MILWAUKEE RIVER ADVISORY COMMITTEE
Thursday, April 24, 2025
6:00 PM
North Conference Room

City of Mequon FEMA Floodplain Mapping Review
M Squared Engineering
February 28, 2025

Figure 1. HEC-RAS Cross-Section of Pioneer Road over the Milwaukee River

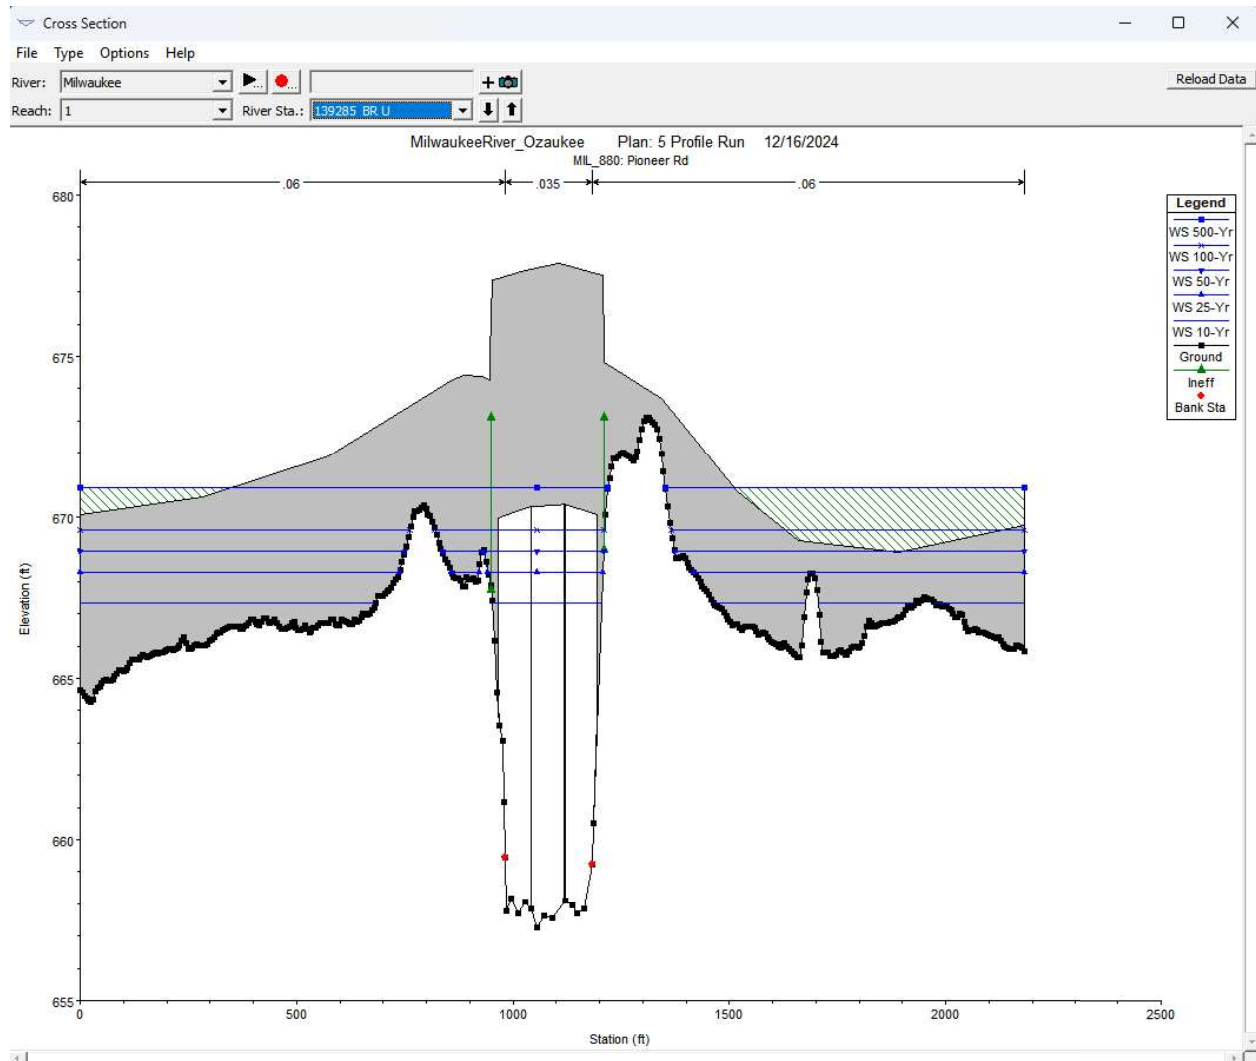
Ineffective flow areas are used in hydraulic modeling to indicate an area of inundation of flood waters, but not an area that is conveying active flow. For example, this could be used to delineate ponded water behind a roadway embankment where the water is not actively flowing. The ineffective flow locations in the HEC-RAS model seem somewhat random and do not have elevations associated with them. In the model, Pioneer Road, Highland Road, and Mequon Road all experience overtopping, but due to the way ineffective flow has been used in the model this

conveyance is not being recognized properly. Ineffective flow removes capacity from the floodplain and typically increases the height of the water surface elevations. If the overtopping was modeled more accurately, it is possible the water surface elevations could decrease at these crossings. Figure 1 shows the cross-section at Pioneer Road where overtopping is shown but is marked as ineffective flow.

Figure 3. HEC-RAS Cross-section showing LOB not containing the water surface elevations

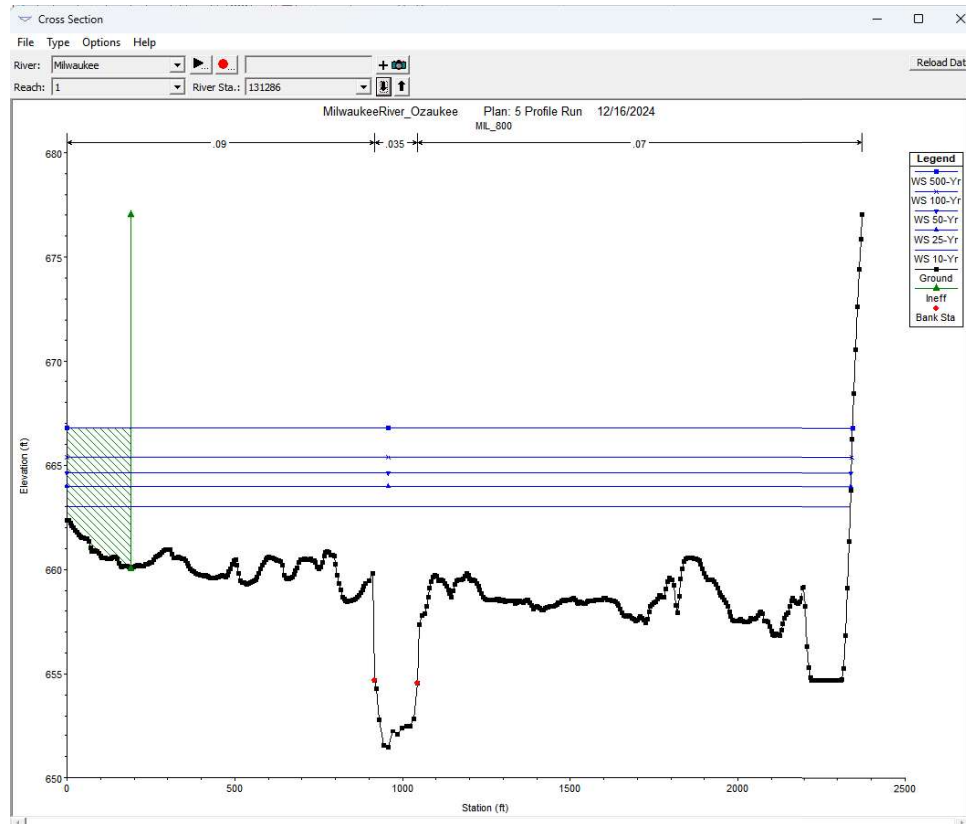
Several cross sections have computed water surface elevations above the far left and right stations. This results in “The cross-section end points had to be extended vertically for the computed water surface” errors. Either these cross sections need to be extended with additional survey data or computer water surface elevations should be below the cross-section end points. Figure 3 shows an example of a cross-section where the left overbank (LOB) does not extend far enough to contain the water surface elevations.

Figure 4. HEC-RAS Cross-section ineffective flow and floodway encroachments

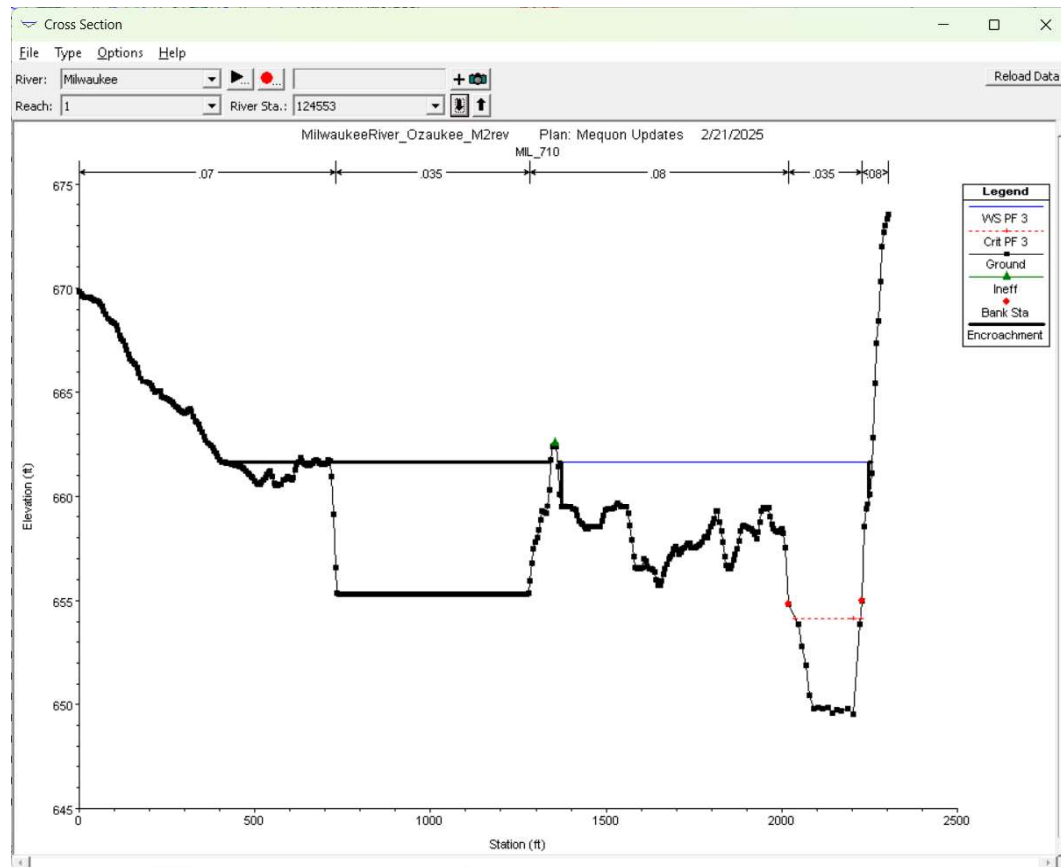
Floodway encroachments changed appropriately with the modeling effort. Ineffective flows were added where elevations were not inundated until overtopped. Permanent ineffective flows were also added as appropriate. The test for ineffective flow is, “Does it get wet?” and “Does it flow?” The answer should be YES, it does get wet, and NO it does not flow to meet permanent ineffective flow criteria. This modified the floodway limits from the FEMA maps and generally were narrower. A typical reduction is shown below. The heavy black line on the left shows the floodway encroachment just beyond the small green triangle that represents ineffective flow. In the cross section below the floodway limits are approximately half of the floodplain limits. However, it is

important to note that encroachment limits varied along the Milwaukee River and were highly dependent on channel geometry and resultant water surface elevations.

Figure 5. HEC-RAS Trinity Creek 100-year profile plot

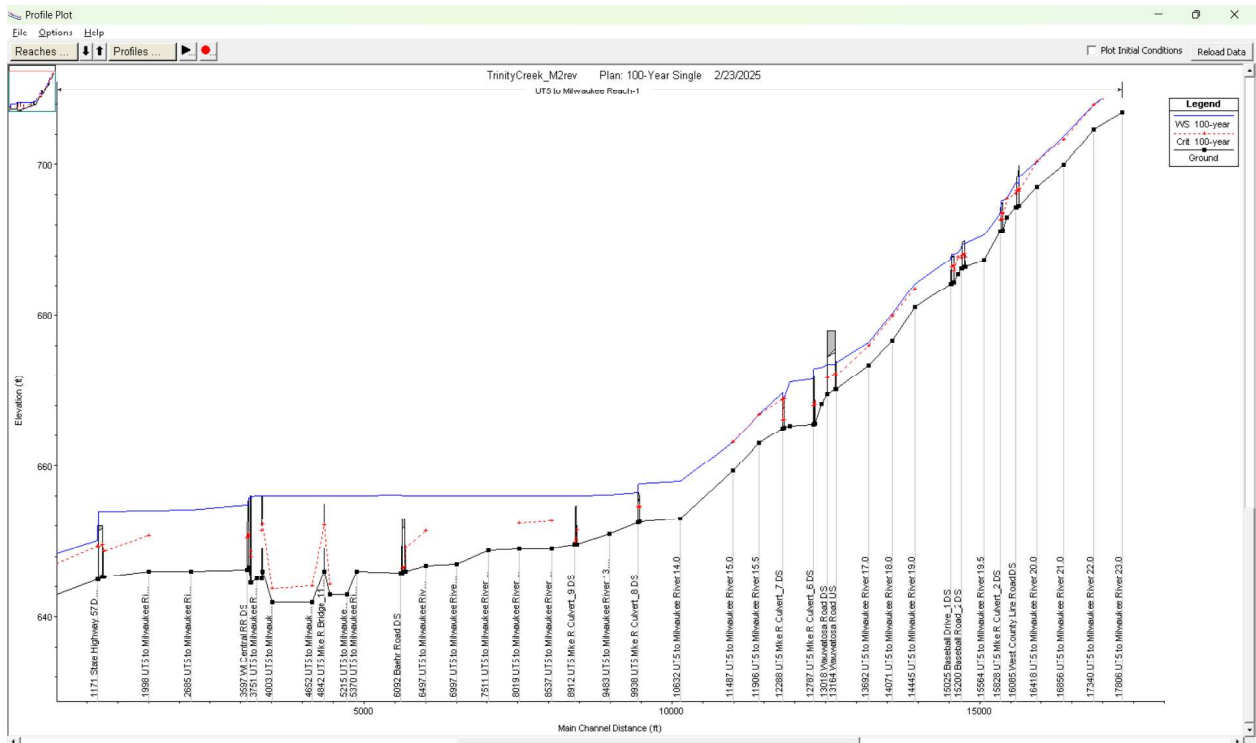
The Milwaukee River has a published backwater condition on Trinity Creek of 655.1. M Squared computed lower water surface elevations of 653.5, a little over 1.5-feet lower. Projecting the Milwaukee River elevation of 653.5 into Trinity Creek only impacts the section from State Highway 57 downstream to the confluence. Upstream of State Highway 57 to the Central Wisconsin Railroad water surface elevations reduced from the FEMA elevations of 655.6 to 655.8 about one to one and a half feet to 654 to 654.9.

Upstream of the Central Wisconsin Railroad computed water surfaces reduced about one foot compared to the FEMA published results to 656 from 657.1. The end of this area corresponds to

FEMA cross section F and results upstream were similar between the FEMA and M Squared models.

Upon completion of the Trinity Creek modeling M Squared suggests the following recommended changes to the HEC-RAS modeling.

The Milwaukee River backwater condition will result in a lower computed water surface elevation for Trinity Creek from the confluence with the Milwaukee River to FEMA cross section F. This elevation reduction also corresponds with a narrower floodway encroachment. Due to the stringent floodway encroachments for the State of Wisconsin the floodway limits are very close to the floodplain limits. Therefore, there will not be a significant reduction in floodway limits beyond the water surface elevation reductions.
